Product Change Notification / CENO-26WFQV556

CCB 5170 and 5170.001 Initial Notice: Qualification of MTAI as a new assembly site for selected A3P0xx, A3PN0xx, AGL0xxxx and AGLN0xxxx device families available in 68L VQFN (8x8x1mm) and 48L VQFN (6x6x1mm) packages.

QUALIFICATION PLAN SUMMARY

LEAD FRAME COMPARISON – VQFN 68L

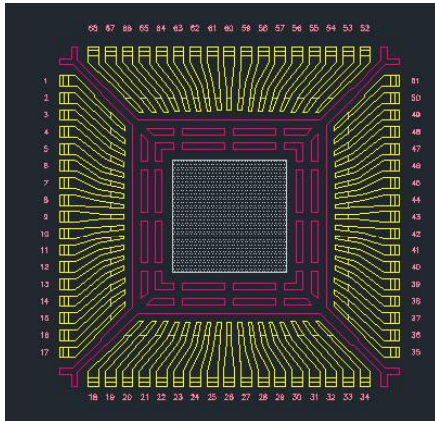
Lead frame DAP surface prep	Ag Ring Plating
Lead Plating	Matte tin
Lead-Frame Paddle Size	125x125 mils

MTAI

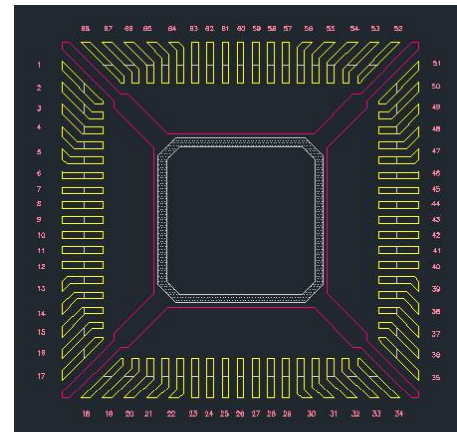
Lead frame DAP surface prep	Ag Ring Plating
Lead Plating	Matte tin
Lead-Frame Paddle Size	122x122 mils

LEAD FRAME COMPARISON – VQFN 48L

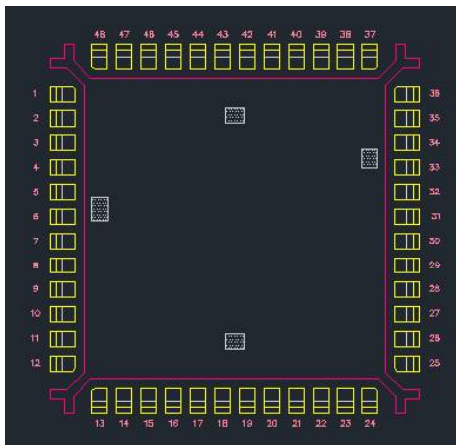
Lead frame DAP surface prep	Ag Ring Plating
Lead Plating	Matte tin
Lead-Frame Paddle Size	193x193 mils

MTAI

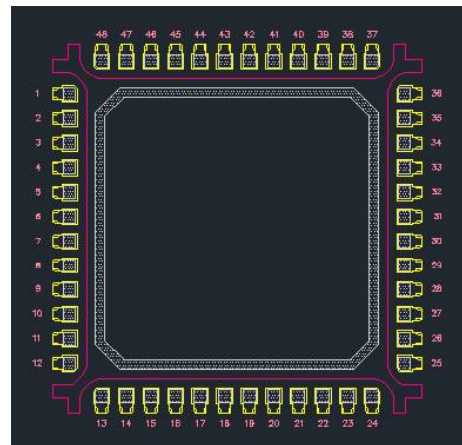
Lead frame DAP surface prep	Ag Ring Plating
Lead Plating	Matte tin
Lead-Frame Paddle Size	193 x 193 mils
